**October 11, 2023
7:00 PM
Planning Board Agenda**

Continue review of application for Site Plan Approval and Special Use Permit, personal wireless service facility, 375 Washington Avenue, submitted by Verizon Wireless of the East, LP (dba Verizon Wireless)

This letter is provided in response to the comments raised in the May 8, 2023 memorandum prepared by Mr. John Clarke, with John Clarke Planning and Design. We offer the following responses on behalf of the applicant, Verizon Wireless:

This letter is provided in response to the comments raised in the May 4, 2023 memorandum prepared by Mr. John Russo, P.E. with Lanc & Tully, P.C. We offer the following responses on behalf of the applicant, Verizon Wireless:

Height Justification (Mid-Band Coverage 2100MHz)

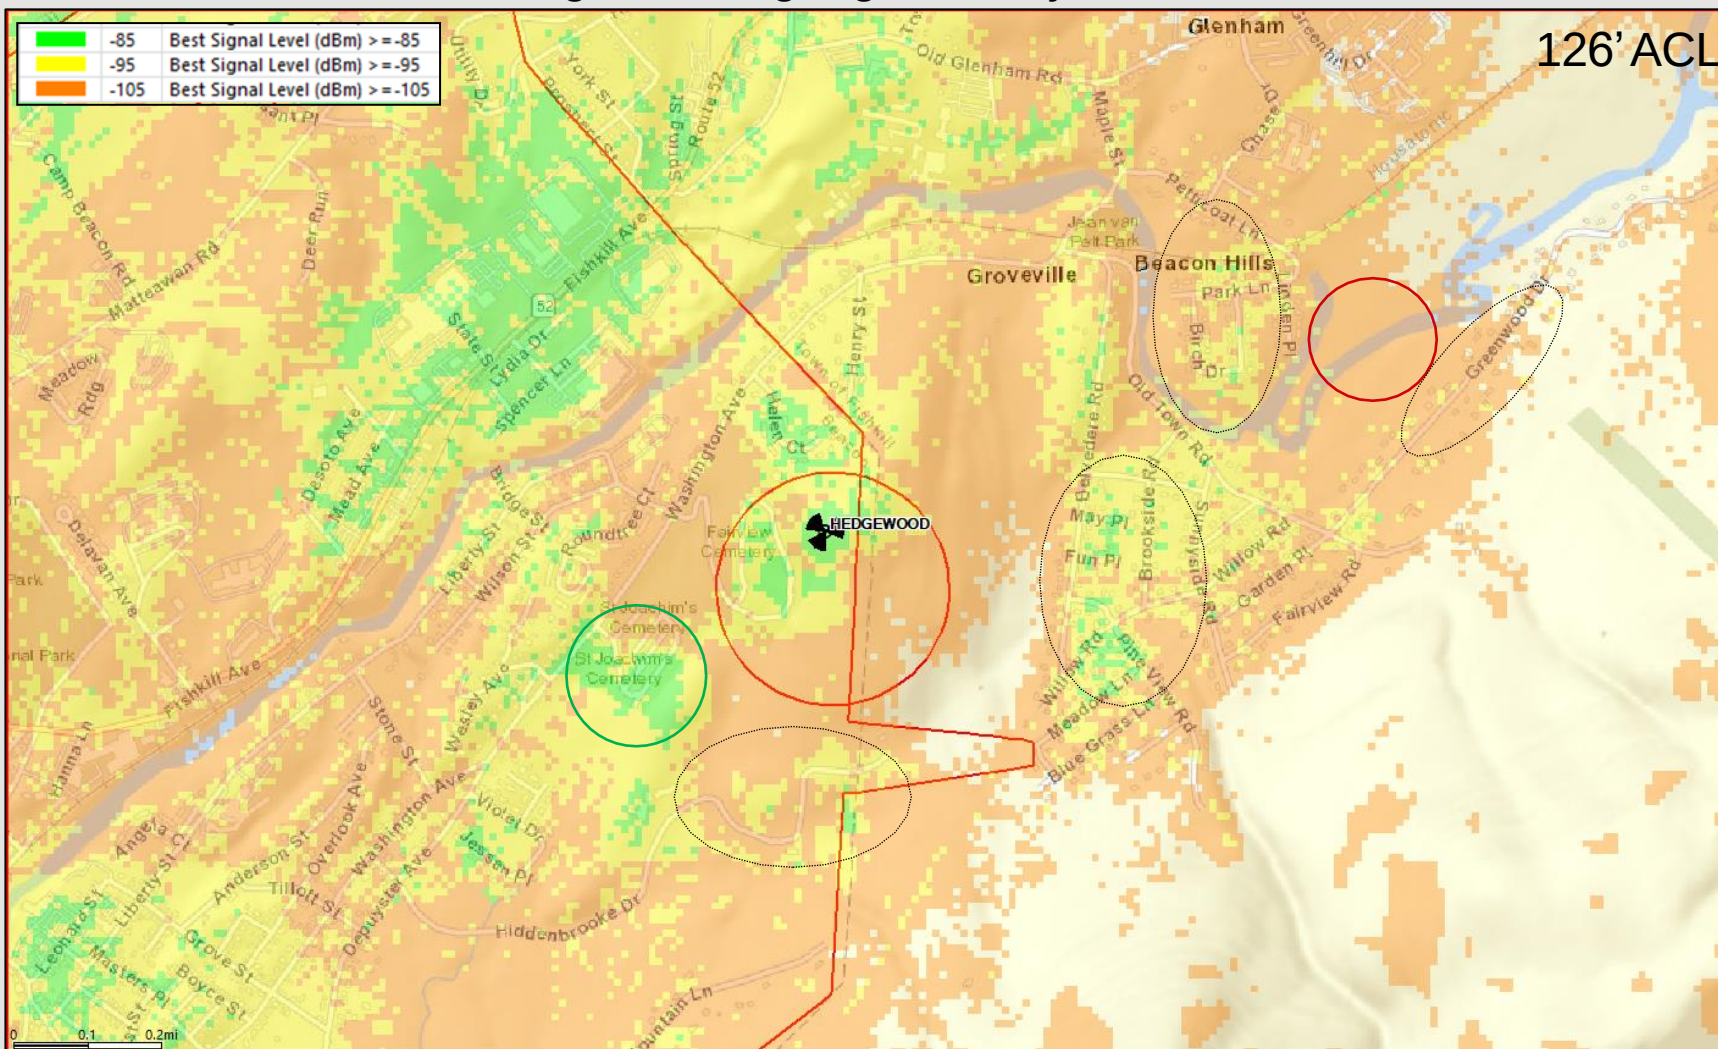
The map above represents mid band coverage from existing sites + Hedgewood WT site at 126' Antenna Centerline (ACL) which is 10ft higher than the proposed ACL(116'). The purpose of adding mid band coverage plot at higher ACL is to show that a higher ACL will certainly result in improve mid band coverage but the improvement is not significant enough to raise the antenna by another 10ft.

Drone Views to Old Town Rd Area (Focus Area 2)

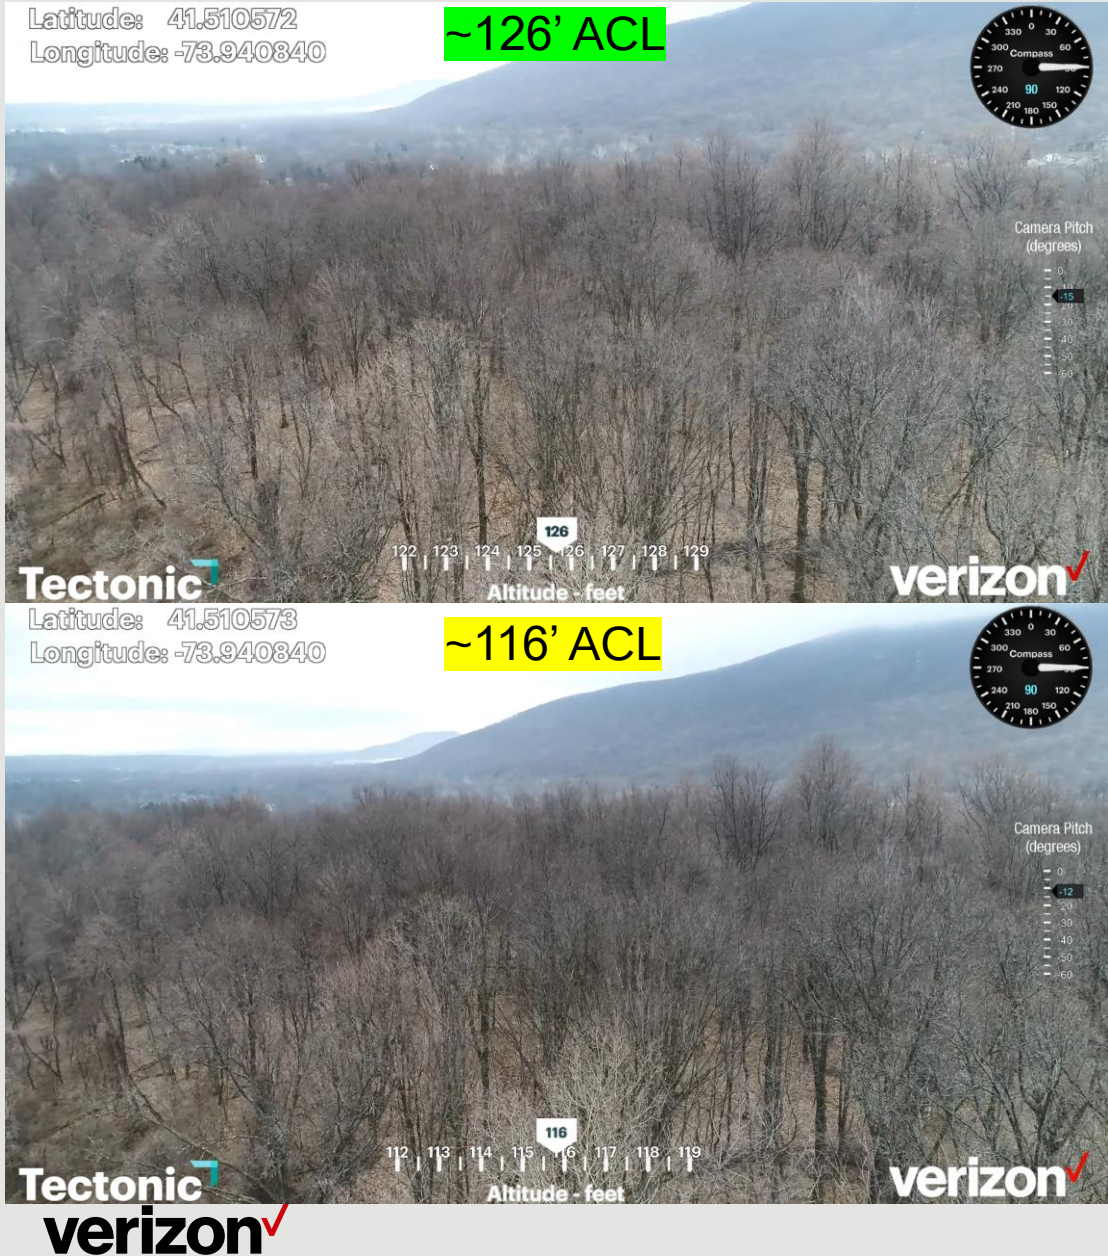
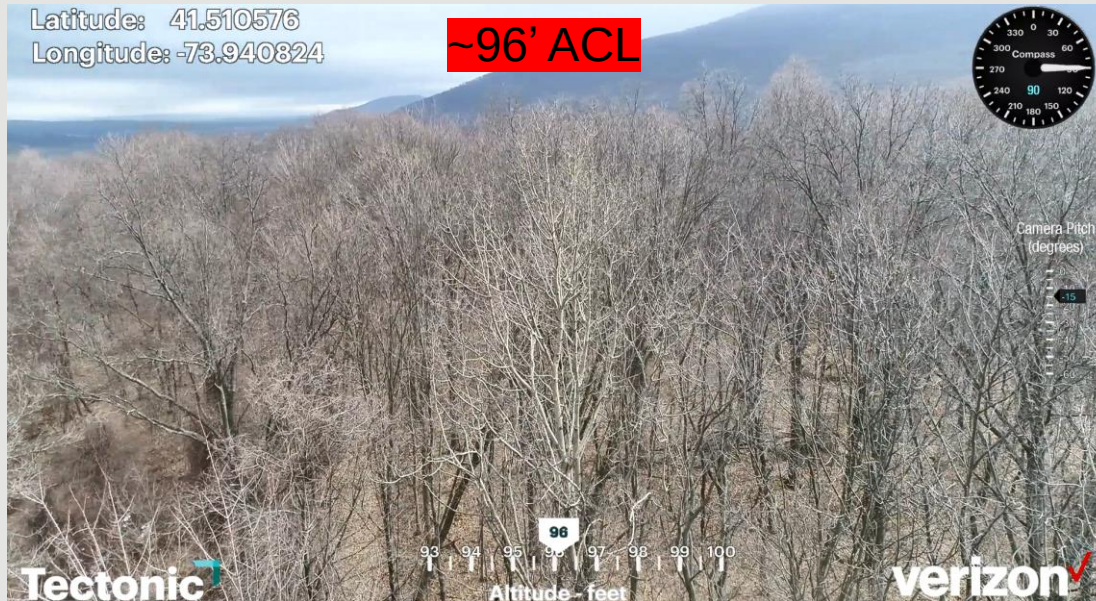
It is clear that there is better line of sight (LOS) to the Old Town Rd area at 126' when compared to 116'. At 116' ACL there are area trees and terrain obstructions impacting the "RF far field" degrading coverage capabilities especially at the higher line of sight (LOS) frequencies (mid-band). This significantly impacts coverage capabilities and overall site footprint however the proposed 116' ACL is able to provide usable signal in portions of the areas of concern.
